July 29, 2014

Re: Friant Water Authority's comments on the Bay Delta
Conservation Plan and EIR/EIS.

Figure 1. Projected Inflow to Trinity, Shasta, Oroville, and Folsom Reservoirs – NAA, NAA-ELT and NAA-LLT

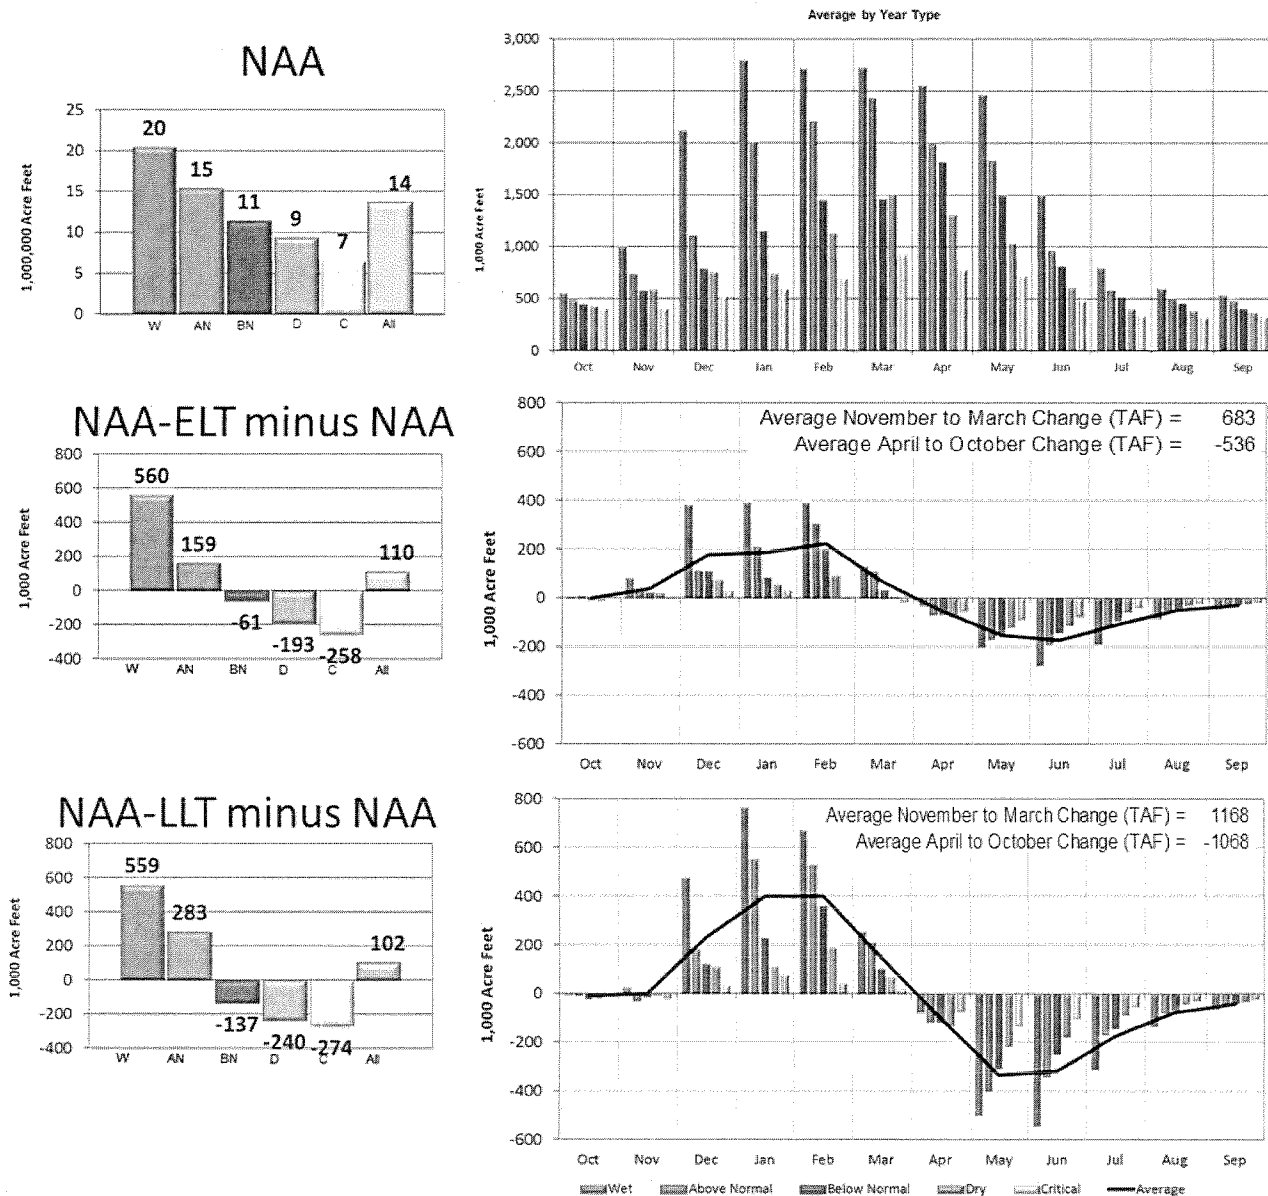
In our opinion, the CalSim II depicted operations that incorporate climate change are not reasonably foreseeable and do not represent a likely future operation of the CVP/SWP. Although an argument is typically made that these study baselines will be used in a comparison analysis with Project Alternatives tiering from these baselines, we believe that the depicted operations do not represent credible CVP/SWP operations and we have no confidence in the results and they are inappropriate as the foundation of a Project Alternative. As such, although the modeling approach may provide a relative comparison between equal foundational operations, we are apprehensive to place much confidence in the computed differences shown between the NAA and Project Alternative Scenarios.

Figure 2. Projected Shasta Reservoir Carryover Storage, NAA, NAA-ELT and NAA-LLT

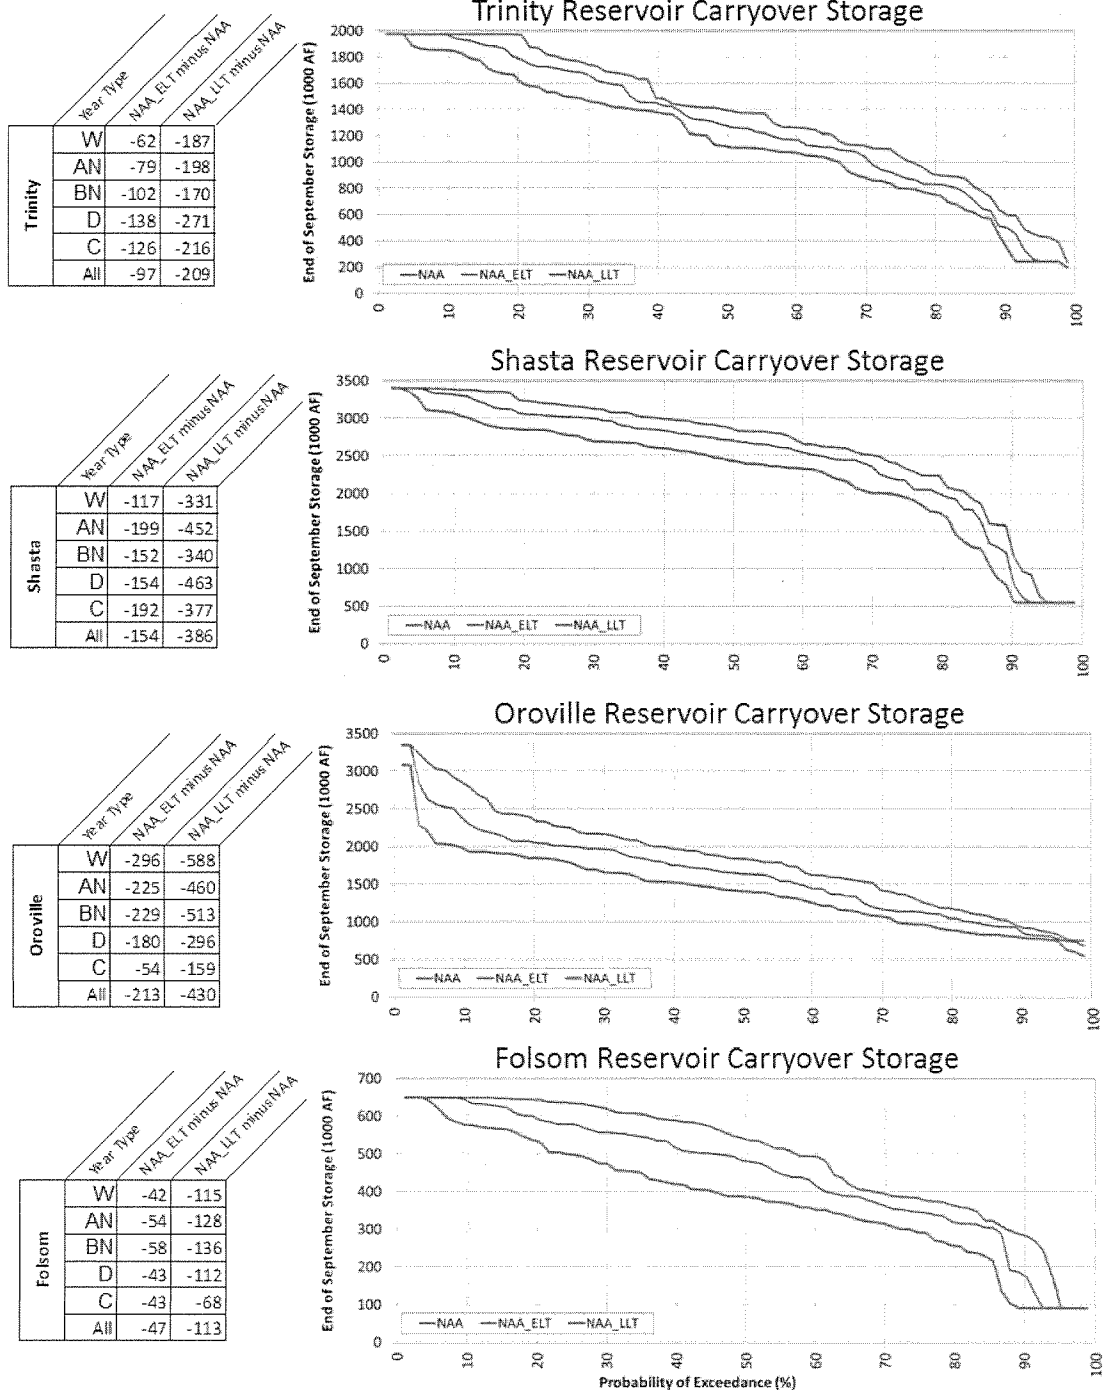
Figure 2 illustrates the typical change in carryover storage as shown for Trinity, Shasta, Oroville, and Folsom Reservoirs. The relatively high frequency (approximately 10% of time) of minimum storage occurring at CVP reservoirs illustrates our questioning of credible operations in the studies.

Figure 3. Projected Inflow to Millerton Lake –NAA, NAA-ELT and NAA-LLT

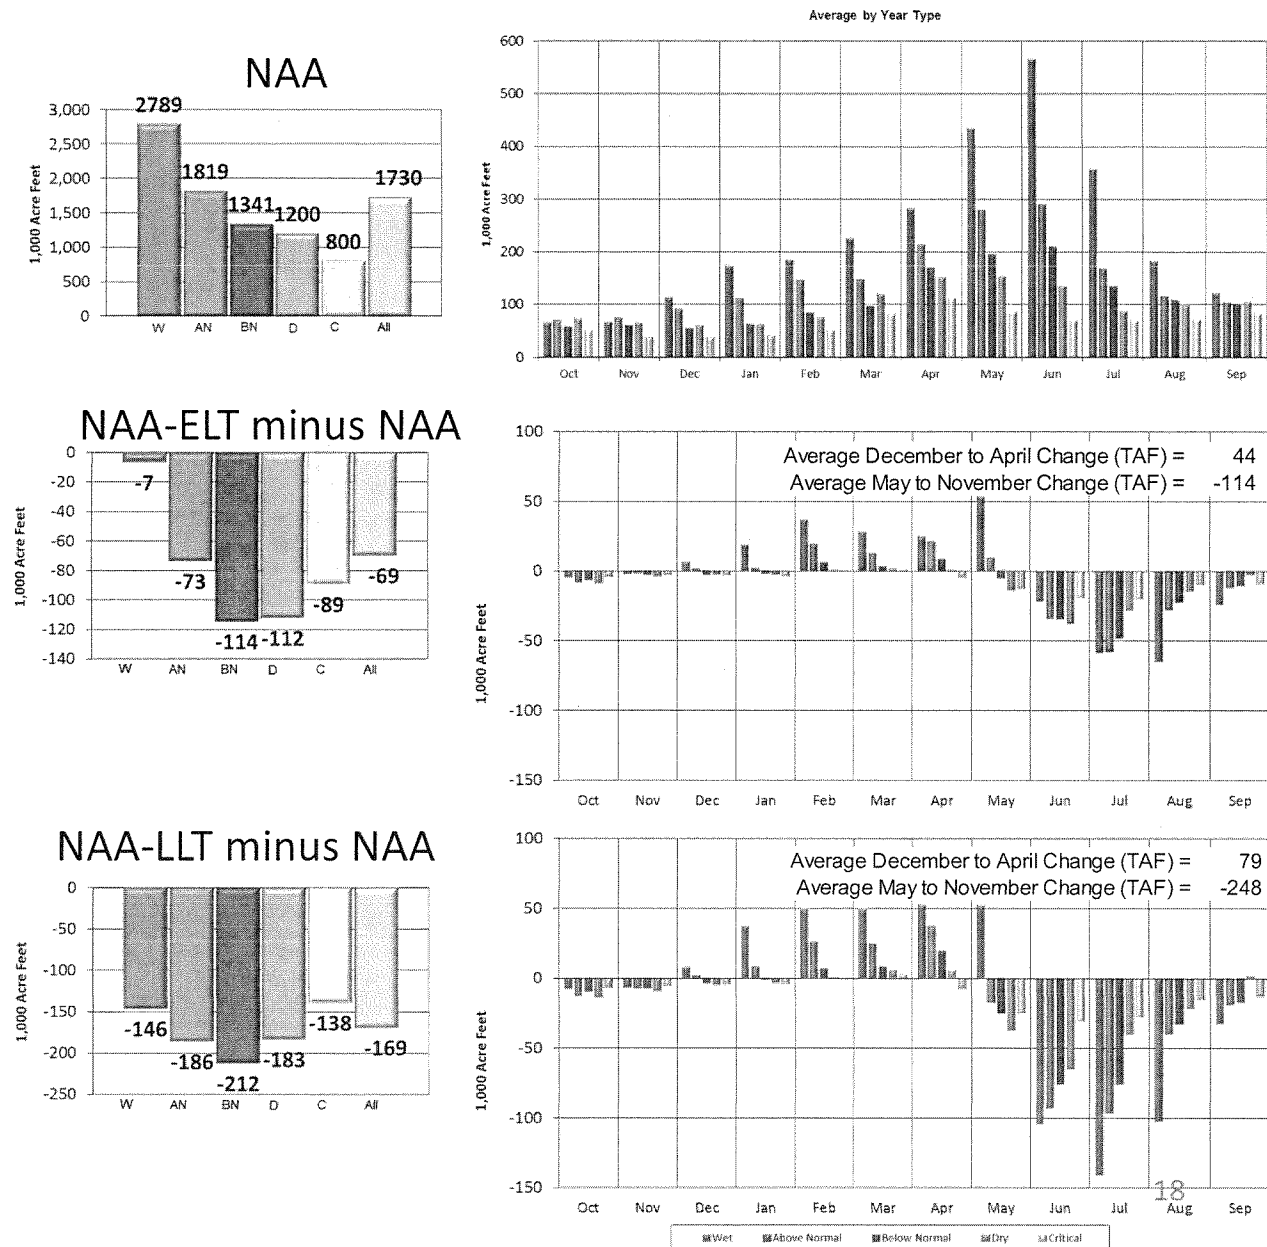
San Joaquin Valley reservoirs are depicted with an overall decrease in annual runoff with some shifting of runoff from spring to winter, but mostly just decreases in spring runoff due to a decline in snowmelt runoff during late spring⁵. Figure 3 illustrates the assumed effects of climate change upon inflow to Millerton Lake.

Inflow to Millerton Reservoir in this version of CalSim is input in three separate time series for purposes of depicting the hydrology of potential upper basin reservoirs. Climate change hydrology was inconsistently incorporated at Millerton Reservoir and misapplied to the water supply and flood control operations. The result is an unrealistic operation for river releases and canal diversions. Figure 3 illustrates the projected ELT and LLT changes in Millerton Reservoir inflow incorporated in these studies. On face value of the input data, regardless of Friant Dam river release assumptions the effect of climate change at Millerton Lake will affect water deliveries.

Figure 4. Millerton Reservoir Carryover Storage, NAA, NAA-ELT and NAA-LLT Scenarios

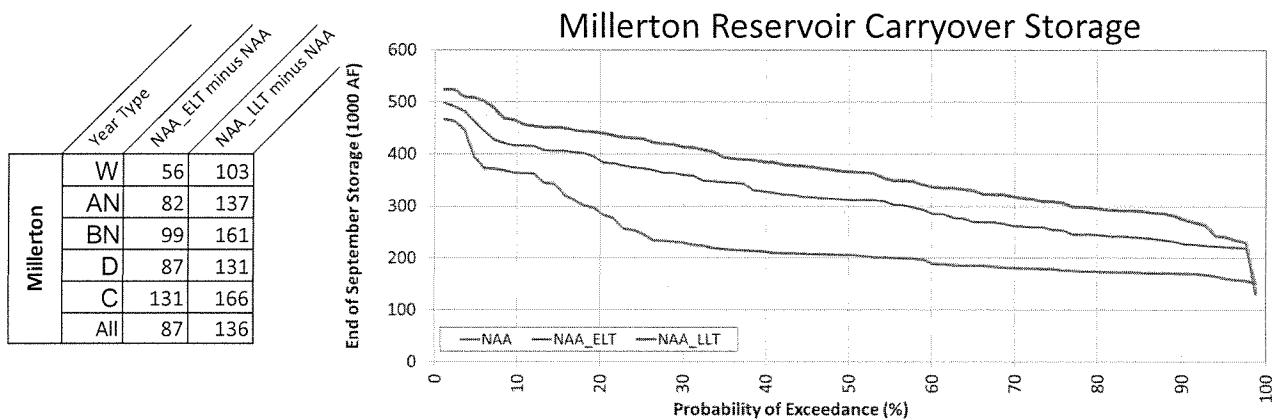
Evidence of the inconsistent inflow problem is shown in the result for the comparison of carryover storage of Millerton Reservoir under the NAA, NAA-ELT, and NAA-LLT Scenarios (Figure 4). Carryover storage is higher in the ELT and LLT Scenarios due to climate change effects to inflow incorporated in reservoir operations but not in the computation of water supply deliveries. Thus, water deliveries are suppressed and the reservoir ends the year with greater storage.

Figure 12. Temperature Exceedance Sacramento River at Bend Bridge Existing, No Action Alternative, ELT

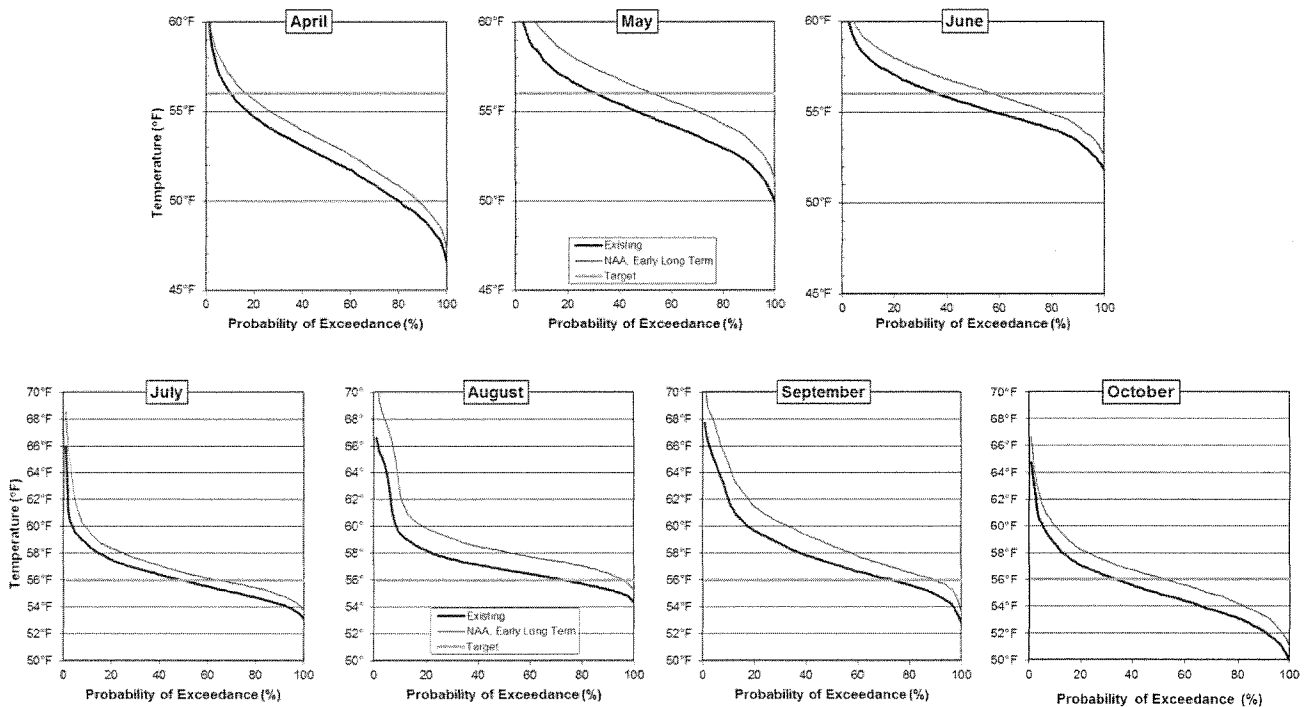
The increase in equilibrium temperatures combined with decreases in storage would lead to water temperature conditions that would likely not achieve the assumed objectives. Figure 12 and Figure 13 illustrate an increase in the probability that a water temperature target of 56°F would be exceeded at Bend Bridge under both the NAA-ELT and NAA-LLT Scenarios. The probability of exceedance increases approximately 5% to 20% depending on the month for the NAA-ELT Scenario and approximately 10% to 40% for the NAA-LLT Scenario.

Figure 19. NDD, Bypass Requirement, Bypass Flow, and Excess Sacramento R. flow for Alt 4-ELT

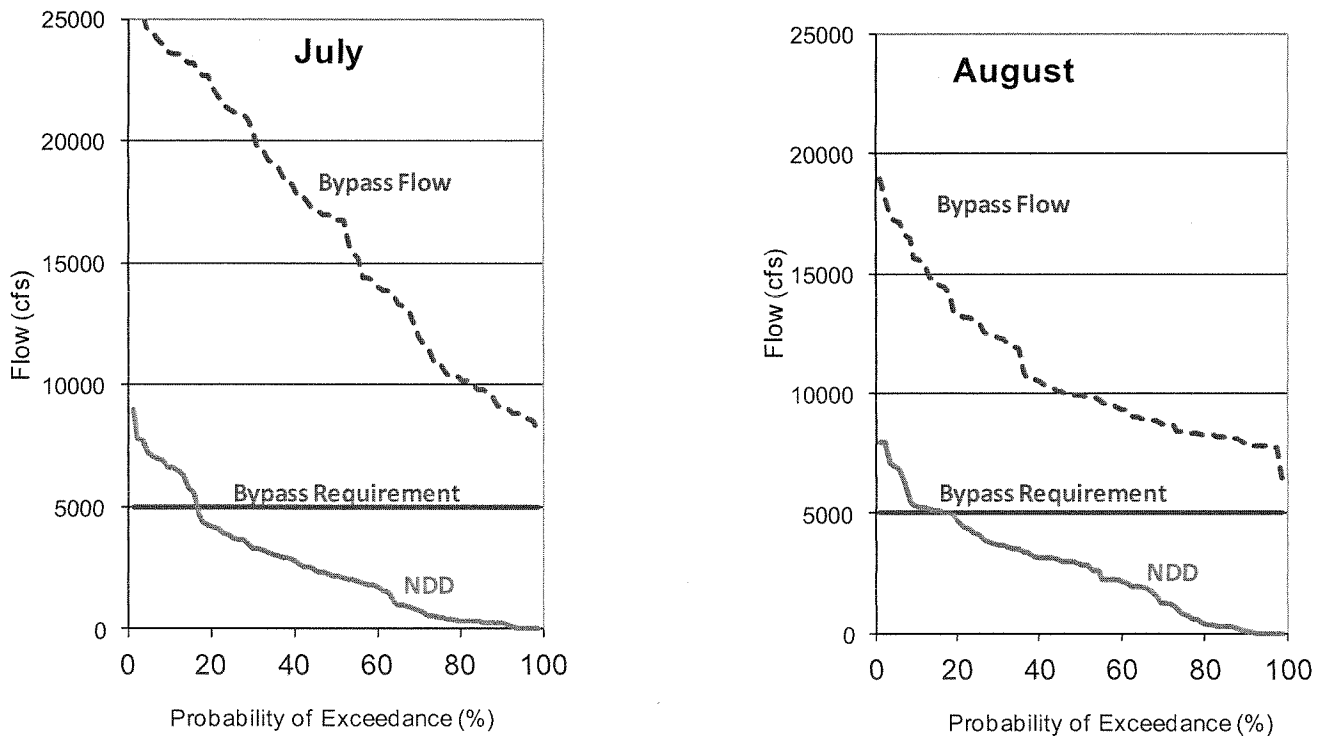
Sacramento River flow below the North Delta Diversion (NDD) must be maintained above the specified bypass flow requirement, therefore the NDD rates are limited to the Sacramento River flow above the bypass requirement. Due to an error in CalSim II that specifies an unintended additional bypass requirement, modeling performed for the BDCP EIRS often bypasses more Sacramento River flow than is specified in the BDCP project description. This error has been fixed in the most recent public releases of CalSim II, but BDCP modeling has not been updated to reflect these fixes. Figure 19 contains exceedance probability plots showing the Sacramento River required bypass, Sacramento River bypass flow, NDD, and excess Sacramento River flow to the Delta as modeling for BDCP. As can be seen in Figure 19, the bypass flow is always above the bypass requirement in July and August. The BDCP version of CalSim sets a requirement for Sacramento River inflow to the Delta needed to satisfy all Delta flow, quality, and export requirements, this requirement should be removed when modeling the NDD.

Figure 22. Alt 4-ELT North Delta Diversion Versus South Delta Diversion for July, August, and September

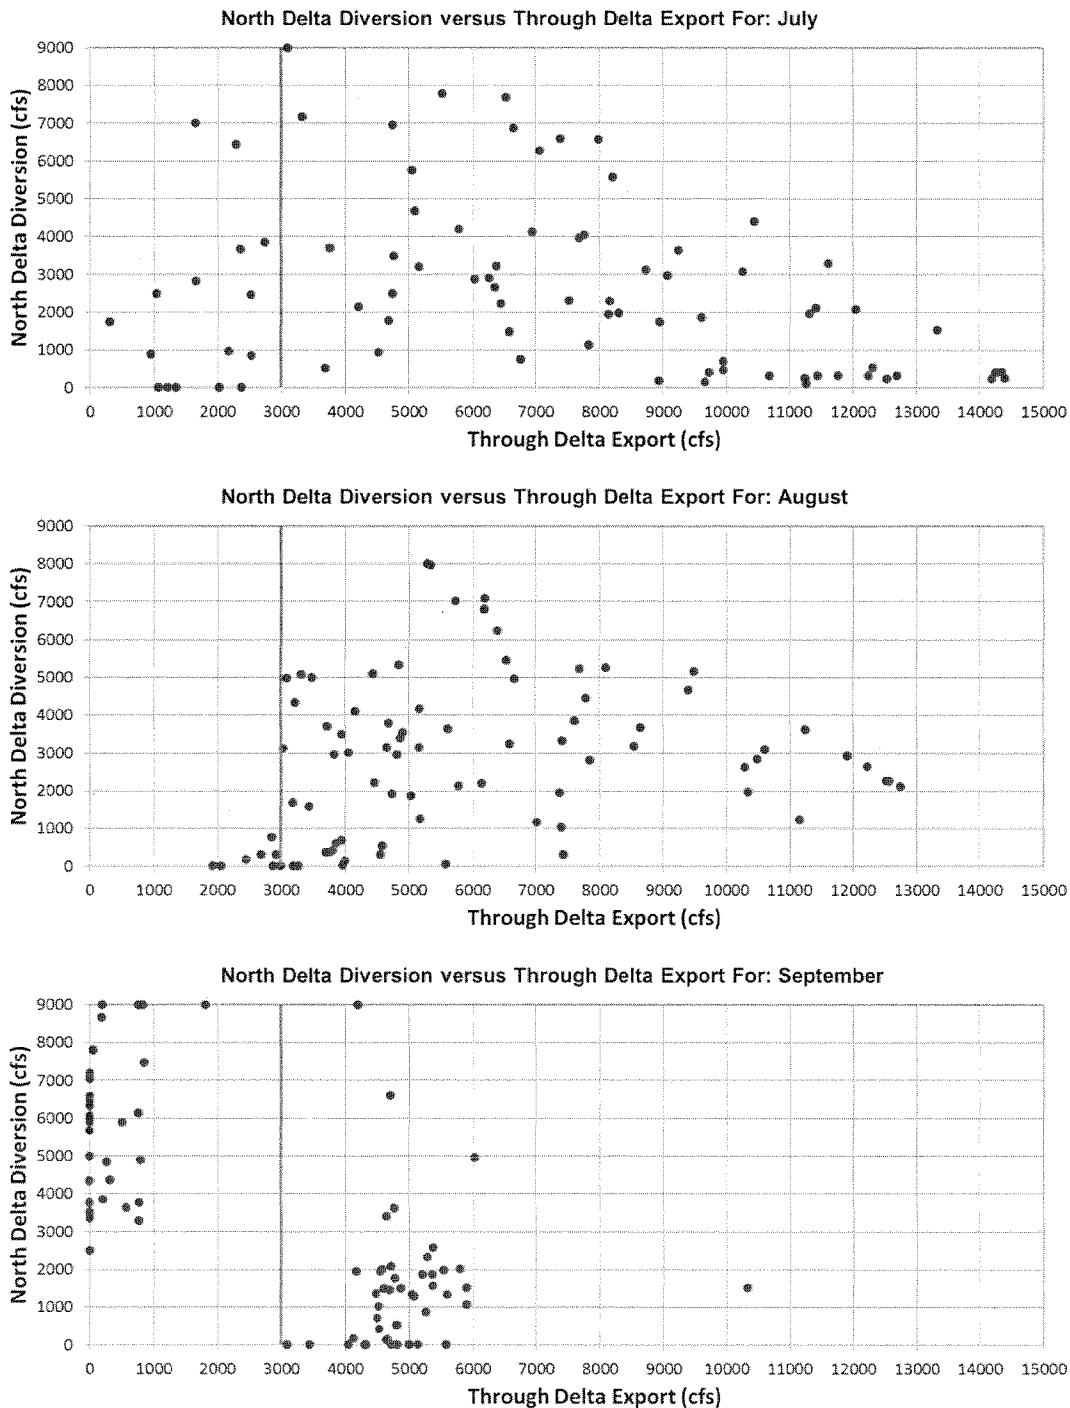
Figure 22 contains figures for July, August, and September for Alt 4-ELT that plot NDD against SDD. In the months of July to September SDD are occasionally very high, exceeding 14,000 cfs in July, with minimal NDD. This occurs due to outdated model code that imposes an instream flow requirement in Sacramento River flow below Hood in excess of the bypass criteria prescribed in the BDCP. There are numerous occurrences when bypass flows prescribed in the BDCP are exceeded and SDD are higher than expected. On the other hand, there are also many times when NDD are above minimum pumping levels and SDD are below the BDCP prescribed 3,000 cfs threshold indicated by the green line in Figure 22. For unknown reasons, the model code requiring SDD to be greater than 3,000 cfs before NDDs occur from July through September is deactivated in the BDCP modeling of this Alternative.

Figure 23. South Delta Diversion at Banks

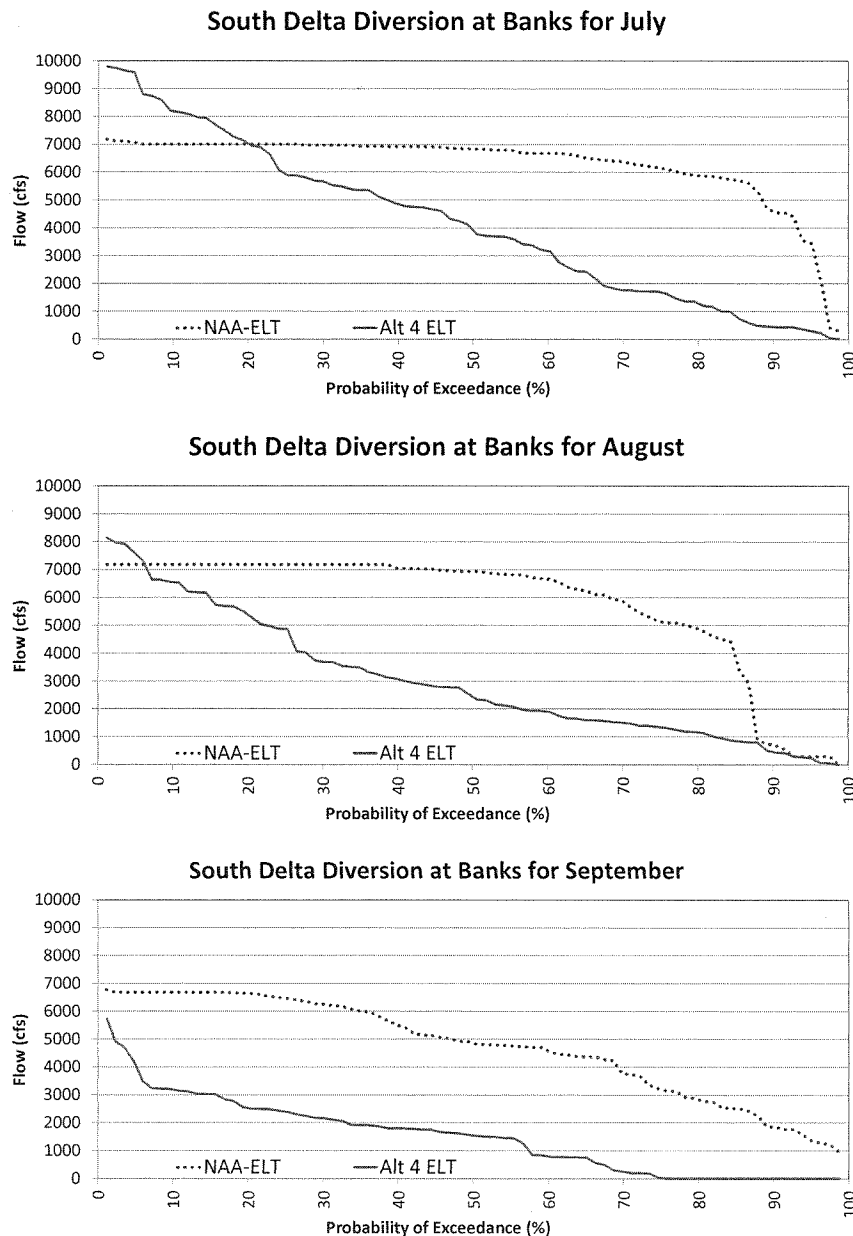
South Delta Diversion at Banks is not limited to existing permit capacity of 6,680 cfs and pumping may reach full capacity of 10,300 cfs in July, August, and September. Figure 23 contains exceedance probability charts of South Delta Diversion at Banks for July, August, and September. The chart for July shows SDD at Banks exceeding existing permit capacity 20% of years, in August this occurs in about 7% of years. There are South Delta diversions at Banks 25% of the time in September while diversions from the Sacramento River may range from 2,500 cfs to 7,500 cfs.
